Re: Groundwater Treatment Plant Tank Covers ([PR#27-2025](#))
City of Newberg ([PWS ID#00557](#))
Conditional Approval

Thank you for your submittal to the Oregon Health Authority's Drinking Water Services (DWS) of plan review information for the *Groundwater Treatment Plant Tank Covers* for the City of Newberg. On February 13, 2025 our office received 90% plans and specifications needed to cover existing contact and filtration basins for Newberg's groundwater source iron removal filtration plant (WTP-A). On February 14, 2025, I provided comments via email on the submittal and requested that a plan review fee be submitted. A plan review fee payment in the amount of \$825 was received on February 24, 2025.

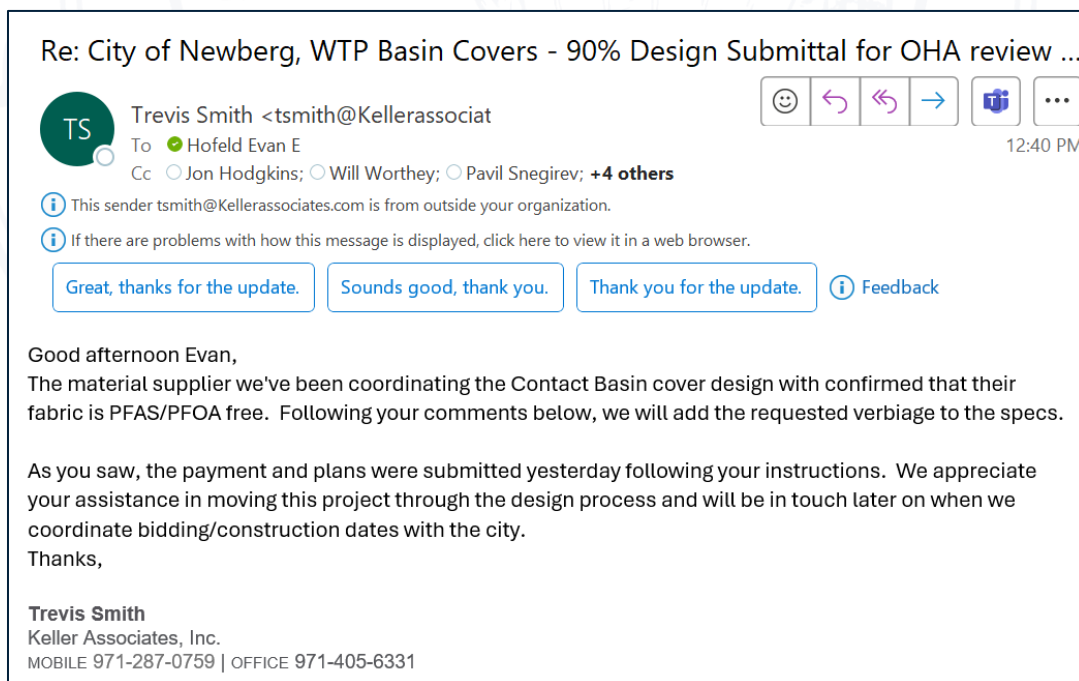
The project includes the installation of steel structures to cover the existing filter basins and a flame-retardant polyethylene fabric cover over the existing contact basins.

The plans are approved subject to the following conditions:

1. The finished structures and related air vents keep runoff from rain and snowmelt, rodents, birds, and insects out of the contact and filtration basins.
2. Materials in contact with water in the basins are NSF-61 approved (the covers as designed do not appear to require any materials to be in contact with the water).
